OLD DUBLIN ROAD - NEW LAWN CEMETERY

STAGE F PART 1 ROAD SAFETY AUDIT

Document Control Sheet	
Document Reference	11614 RSA Stage F Part 1
Report Status	Issue
Report Date	August 2023
Current Revision	B
Client:	Galway City Council
Client Address:	City Hall, College Road, Galway
Project Number	11614

Figure 1-2 Entrance Options

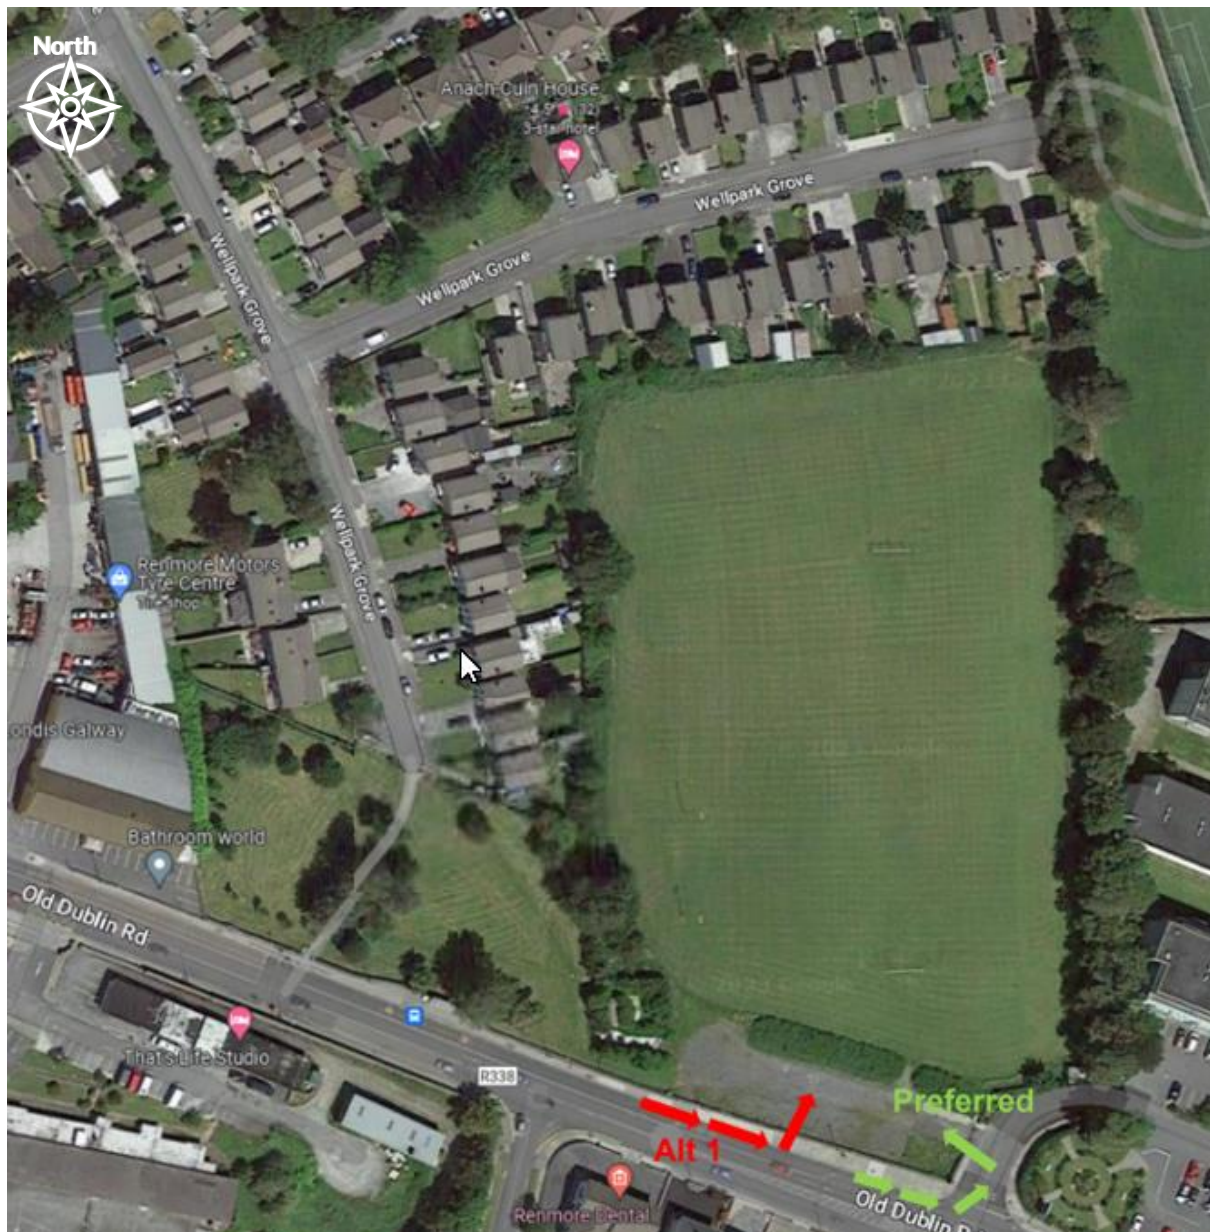
The visibility splay from the existing gate to a vehicle travelling eastbound on the Old Dublin Road is obstructed by the existing boundary wall and proposed vegetation.

Vehicles turning from the Old Dublin Road into the Connaught Hotel will not have sufficient visibility to react if a vehicle turns out of the new entrance onto the link road between the Connaught Hotel and Old Dublin Road.

The proximity of the proposed entrance to the mainline traffic on the R338.

The distance from a vehicle turning off the mainline (from either direction) to a vehicle departing the entrance / queue of vehicle entering the new entrance, may result in sideswipe / rear-end collision.

A queue of vehicles on the link road departing the hotel, may present a problem to vehicles departing the development.

Queuing vehicles on the link road will obstruct vehicles departing the development. This could result in a vehicle stranded in the inbound lane to the Hotel which may be struck by a vehicle turning into the Connaught hotel from the mainline (R338).

It was observed a number of pedestrians departing the Connaught Hotel in the direction of town, cross diagonally in front of the new entrance to the development.

The lack of pedestrian provisions on northwest side of the proposed entrance will result in a continuation of this existing pedestrian pattern. The introduction of the entrance will present a hazard to these vulnerable road users (VRUs).

No designated segregated pedestrian access to the development is proposed.

In the absence of segregated pedestrian and vehicle access, pedestrians (VRUs) will utilise the proposed vehicular access in conflict with vehicles.

The suspension of the bus lane on the eastbound approach to the new entrance and the proximity of the entrance to the Connaught Hotel.

The suspension of the bus lane to accommodate merging traffic into the nearside lane to the Cemetery may result in vehicles turning left into the Connaught Hotel entering the nearside lane early. The vehicles departing the Cemetery directly onto the Old Dublin Road may turn out into the oncoming path of these vehicles, resulting in rear-end / sideswipe collisions.

Proximity of the entrance to the Renmore Park road.

The Audit Team observed vehicles queuing on the Old Dublin Road to right turn onto Renmore Park. Vehicles queuing behind were observed undertaking the queued traffic via the bus lane.

This may result in a collision between a vehicle departing the development and a vehicle performing an undertaking manoeuvre which was not anticipated.

High-sided vehicles queuing to the traffic lights at Renmore Road.

Queuing of buses in the bus lane and high-sided vehicles in the offside lane will obstruct the visibility of drivers departing the development to those travelling westbound towards Galway City. This may result in a collision between a vehicle departing and turning right and a vehicle travelling westbound.

A vehicle which accelerates quickly to make a gap acceptance into town from the development, may suddenly brake due to vehicles breaking on the mainline to allow vehicles exit from Renmore Park.

Boundary wall obstructs the visibility to the new road layout for the Bus Connects.

Reduced visibility will increase the risk of the collision and the severity.

Pedestrians crossing entrance / pedestrian access to the development.

No information was provided on a crossing of the entrance on the R338, Old Dublin Road. A bus stop and pedestrian crossing of the R338 is located to the west of the entrance. As a main arterial route in Galway a number of pedestrians use these facilities. The design should accommodate safe movements for these road users.

The placement of this entrance on the R338, will require segregated pedestrian access to the development. Vehicles turning in right with gap acceptance on the mainline, will accelerate into the entrance across the multi-lanes on the R338. High speeds of vehicles in conflict with VRUs may result in serious collisions.
